Tuesday April 26, 2022
Medway Planning and Economic Development Board
155 Village Street
Medway, MA 02053
LIVE Meeting with Zoom availability

PLAN REVIEW ESTIMATE – Milford Regional Hospital Site Plan (86 Holliston Street):

EVERSOURCE SUBSTATION #65 SITE PLAN 12 & 34 WEST STREET FIELD CHANGES:

MEDWAY MILL – Field Change Requests:

Medway Mills
165 Main St.
Medway, MA

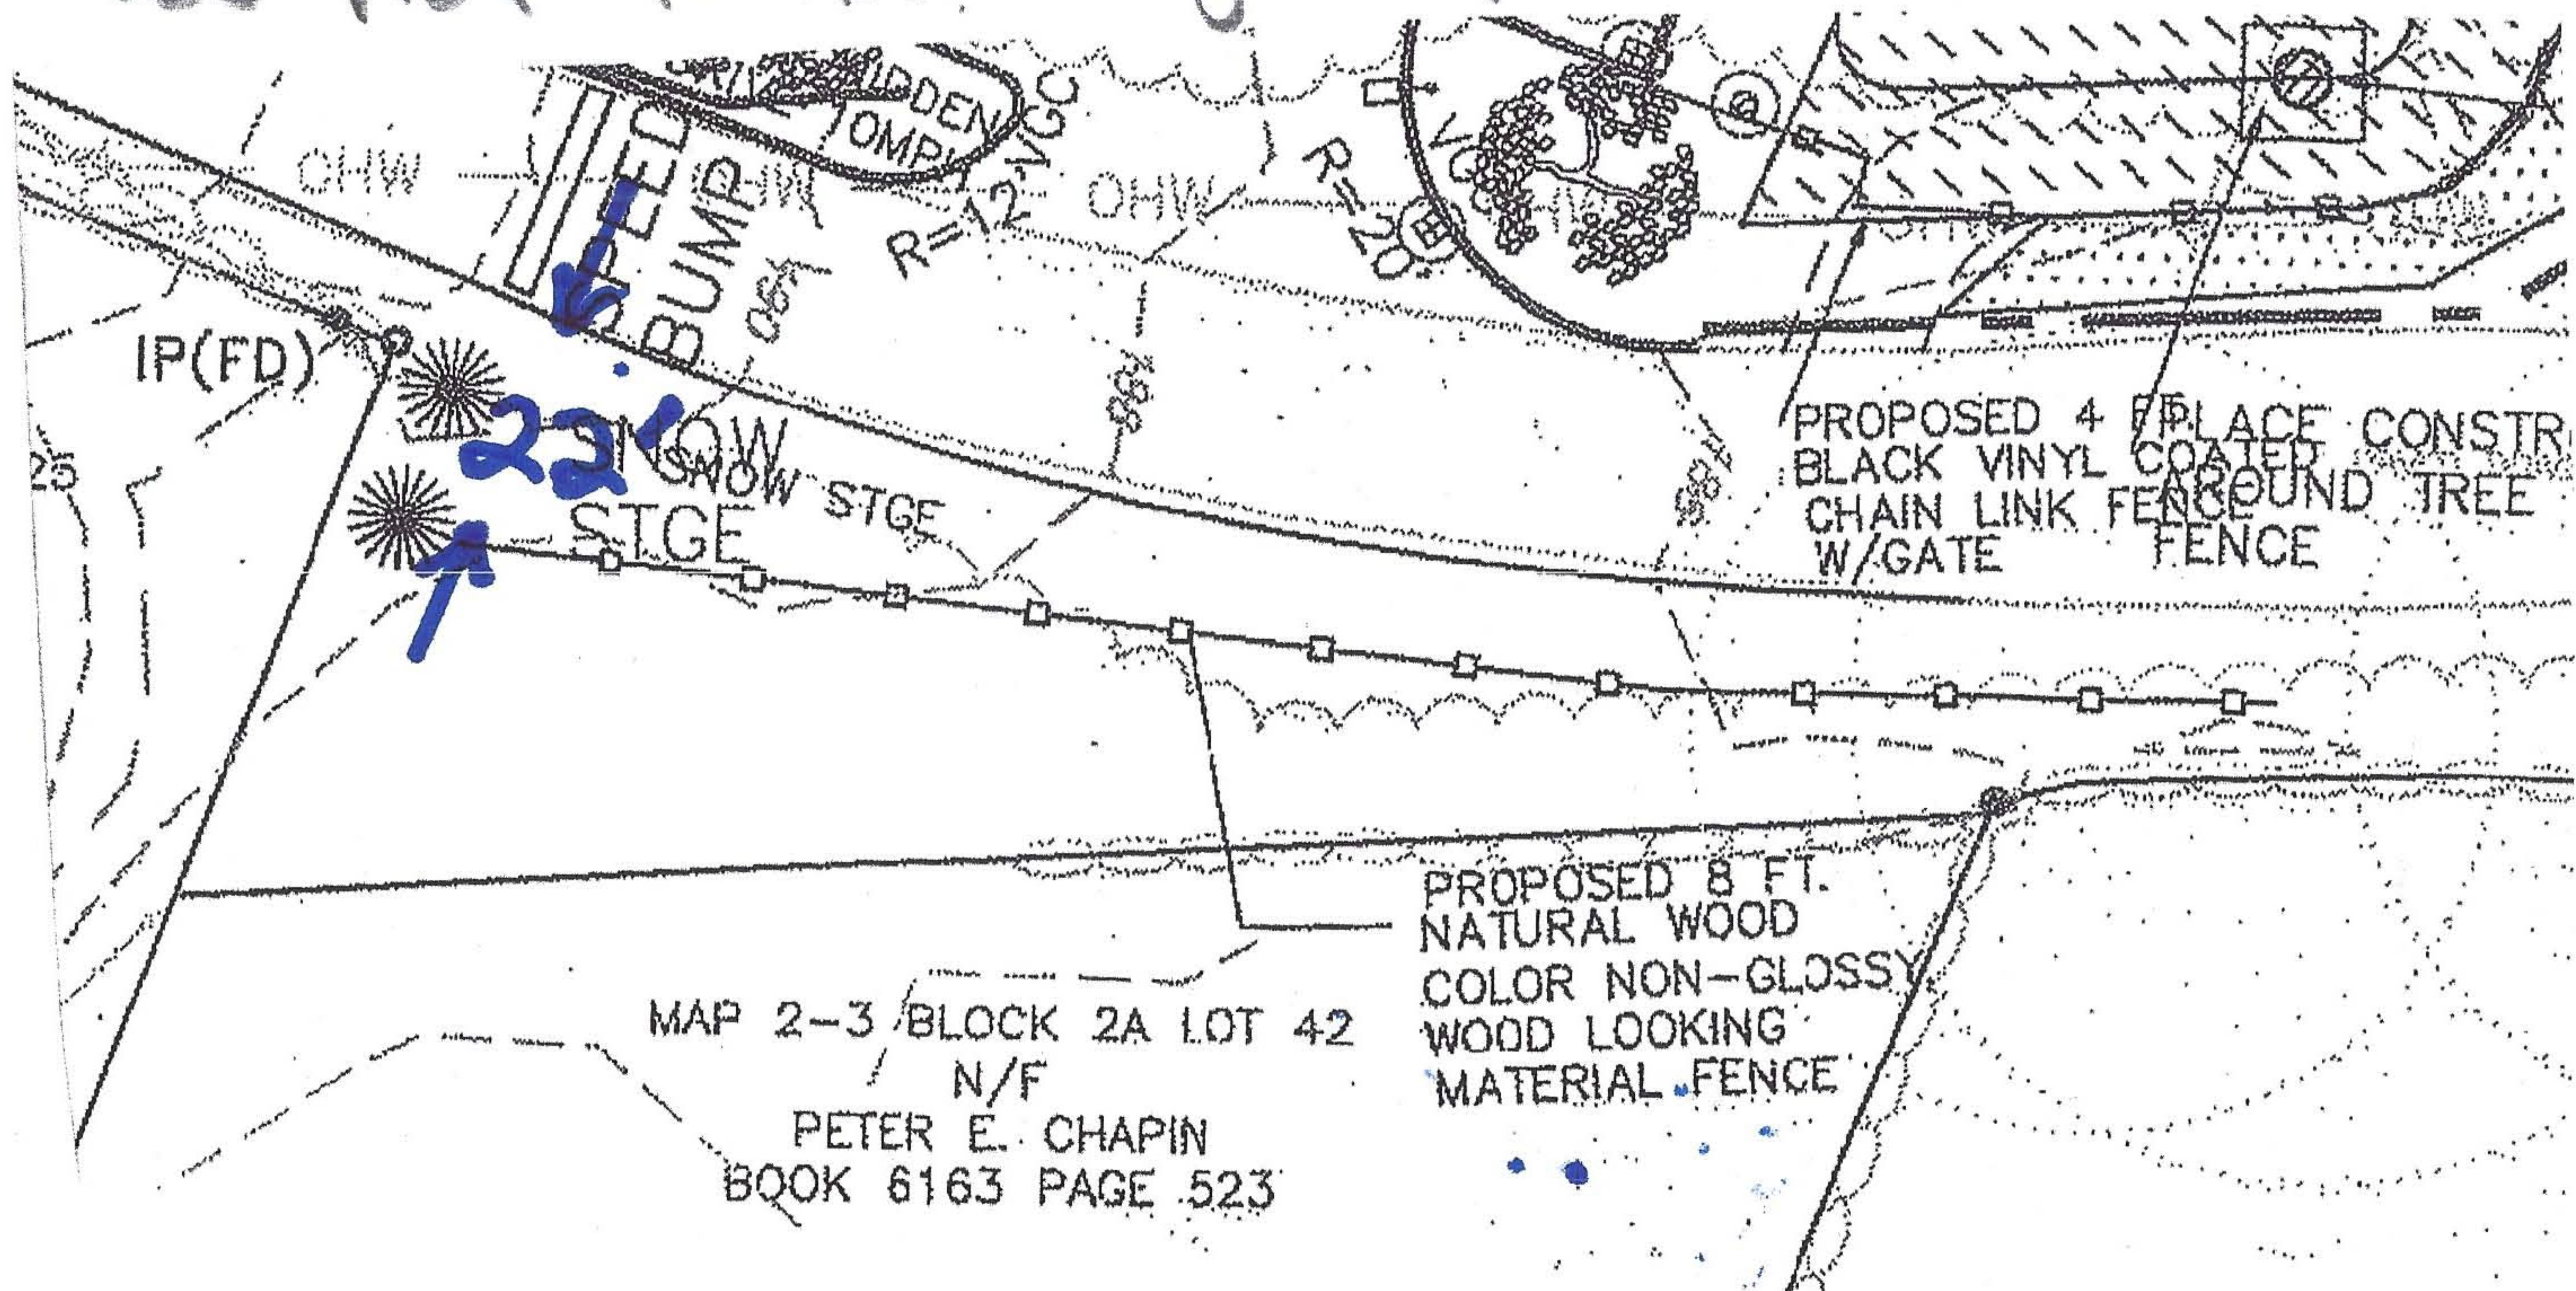
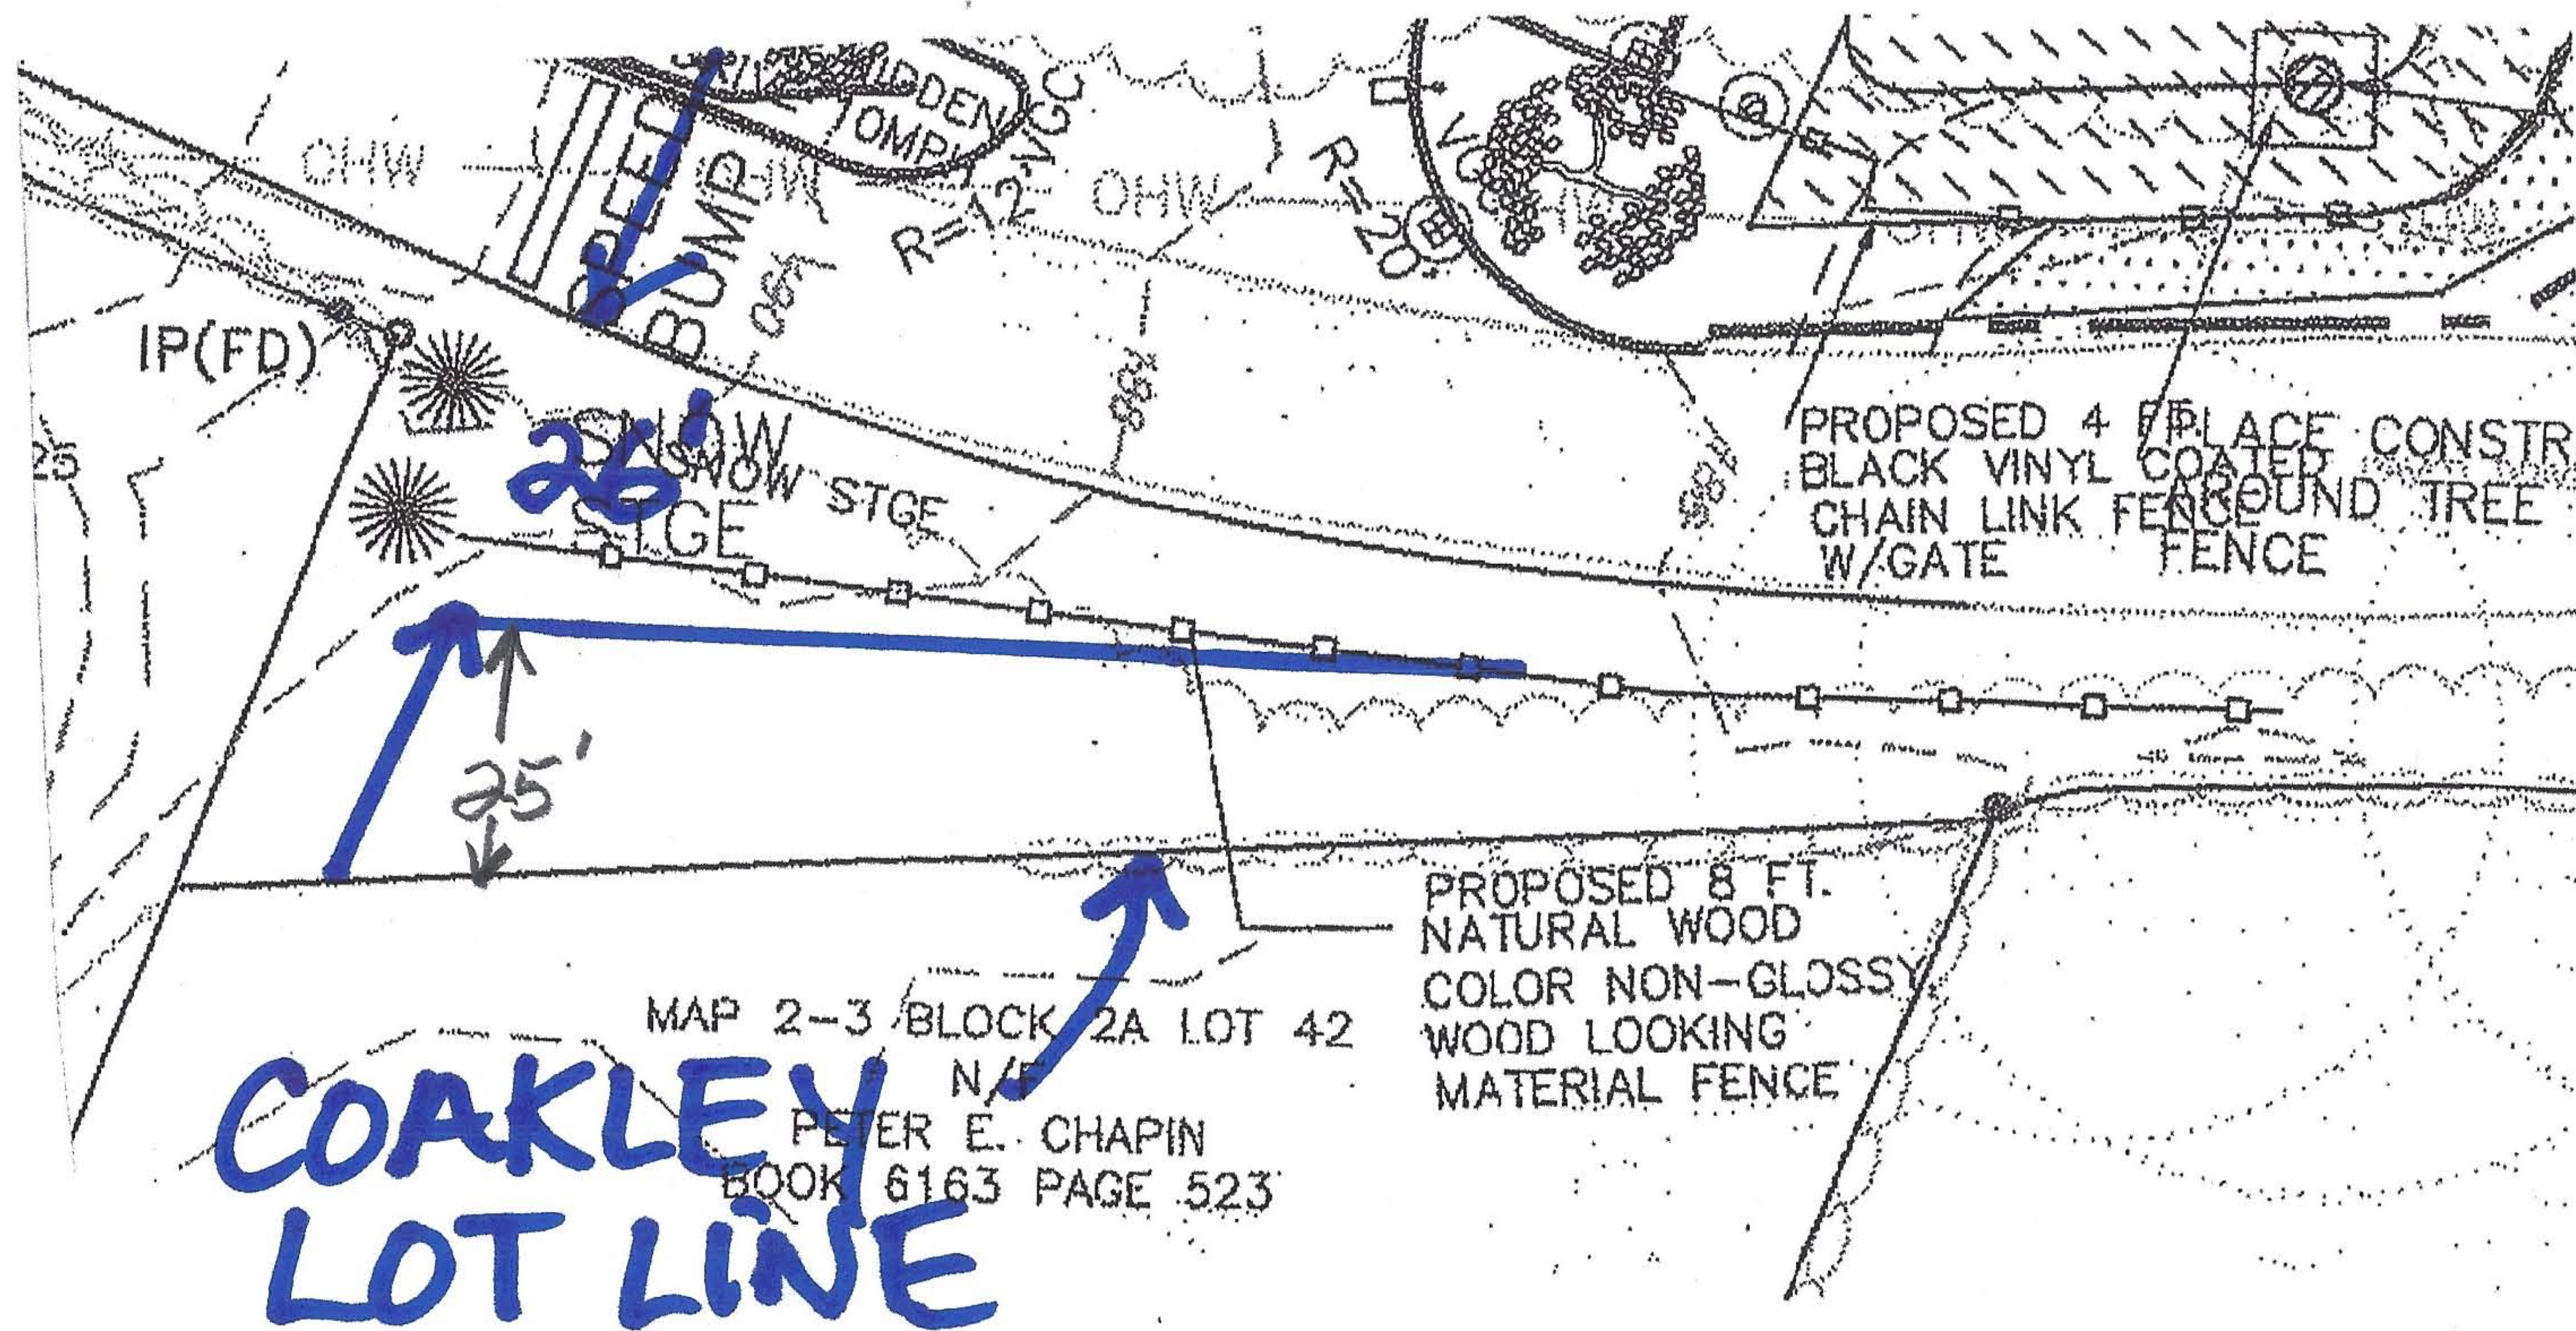
* Fence moved to a 26' +/- offset so
as not to damage fence with snow

Moved back to allow snow storage
without damage to fence

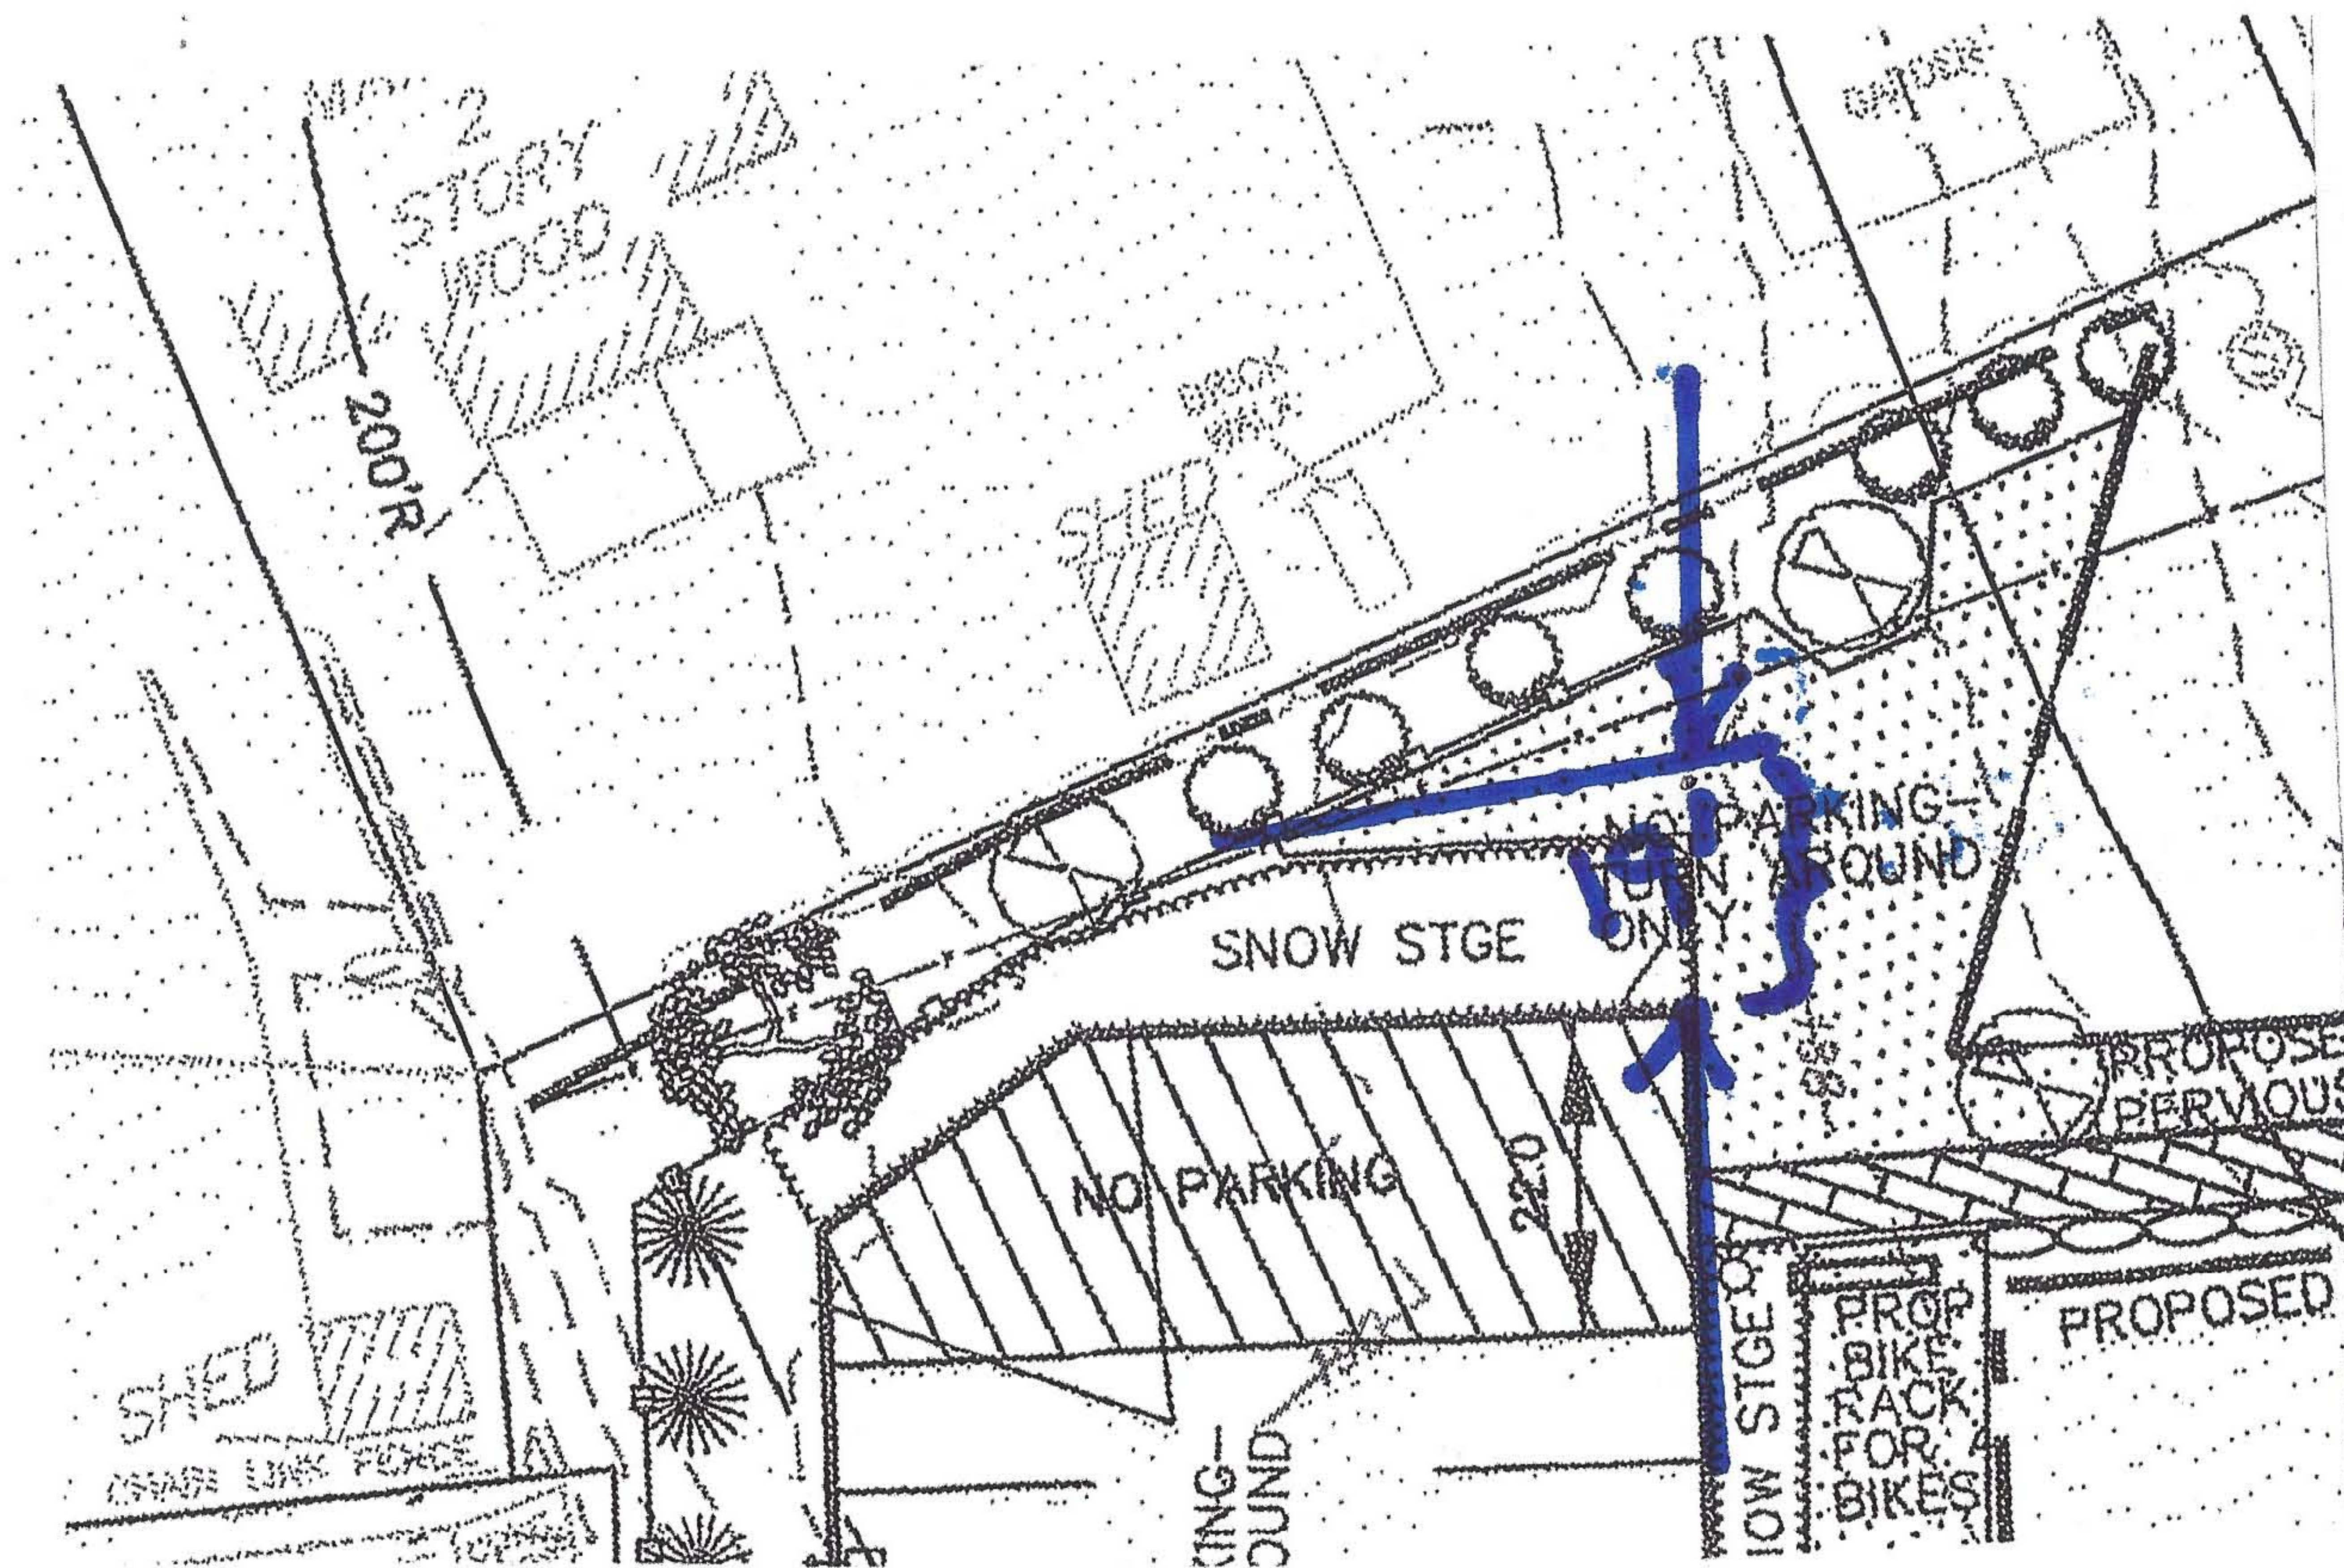
New fence location is $11' \pm$ closer
to Parking lot to allow access for
plantings, prevent planting into stone
wall
Larger area will provide more
light as well

Eliminate last 4'
of Rear fence to
Eliminate blind spot

- The lighting plan was revised and reviewed by Tetra Tech they have no issues with the proposed changes and have reviewed the plan and no light trespass is proposed.
- There is a request to shorten the fence by the four feet will help with sight distance pulling out of the new parking area and should have no impact on screening of the project for the abutters.
- The applicant is also requesting a substitute 5” standing granite opposed to 6” standing granite curbs. The product for 5” is difficult to find. Tetra Tech has no issue with the change in curb.
